# Access Compliance Report

## Public Rights-of-Way (Curb Ramps)

Intersection ID: N/A	Main Street: 6TH_ST	Cross Street: N/A	Location: W
ADA ID: 322FDBEDD13B	Ramp Type: Directional1	Initial Pass/Fail: Pass	Overall Compliance: No
		Severity Score: 0

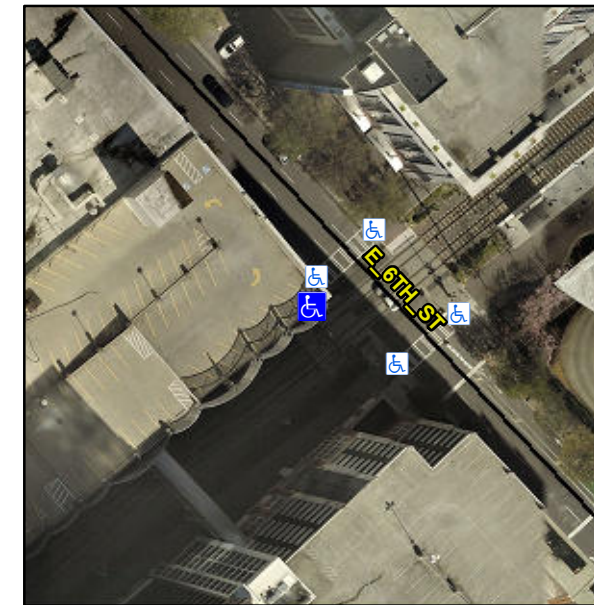
**GB RUN SLOPE 22%**

Compliance	Description	Data	Compliance	Description	Data
N/A	Ramp Length (in)	70.0	Yes	Grade Break?	Yes
Yes	Ramp Width (in)	118.0	No	Grade Break Slope (%)	22.0
Yes	Ramp Slope (%)	3.2	Yes	Grade Break XSlope (%)	1.3
Yes	Ramp XSlope (%)	1.3			
N/A	Flare Type LT	N/A	N/A	Flare Type RT	N/A
N/A	Flare Slope LT (%)	N/A	N/A	Flare Slope RT (%)	N/A
N/A	Flare Traversable LT?	N/A	N/A	Flare Traversable RT?	N/A
Yes	Landing Length (in)	61.0	Yes	DWS Provided?	Yes
Yes	Landing Width (in)	118.0	Yes	DWS Contrast?	Yes
Yes	Landing Slope (%)	0.8	Yes	DWS Length (in)	32.0
Yes	Landing X Slope (%)	0.1	Yes	DWS Full Width?	Yes
N/A	Landing Curb? (Y/N)	N/A	No	DWS Offset LT (in)	23.5
N/A	Shared Landing?	No	Yes	DWS Offset RT (in)	33.0
Yes	Gutter Ponding?	No	Yes	Gutter Slope (%)	0.1
Yes	Gutter Lip Ht (in)	0.0	Yes	Gutter X Slope (%)	0.3
N/A	Painted X Walk1?	No		Road Slope (%)	1.2
	X Walk 1 Direction	To SE		Road X Slope (%)	0.1
	X Walk 1 Width (in)	N/A		Clear Space?	Yes

X Walk 1 Slope (%)	1.2	N/A	Clear Space to XWalk (in)	N/A
	X Walk 1 X Slope (%)	0.1	No	Storm Grate/Utility Hazard?	Yes
N/A	Ramp inside XWalk1?	N/A		Storm Grate/Utility Type	
Yes	Any Obstructions?	No		<b>CDOT ELECTRIC VAULT</b>	
	Obstruction Type		Yes	Surface Condition? (G/P)	Good
			N/A	Curb Slope (%)	0.1

**Remove & Replace Entire Ramp.  
Utility Present.**

**R304.5.3, R305.2, R302.3, R402.2**
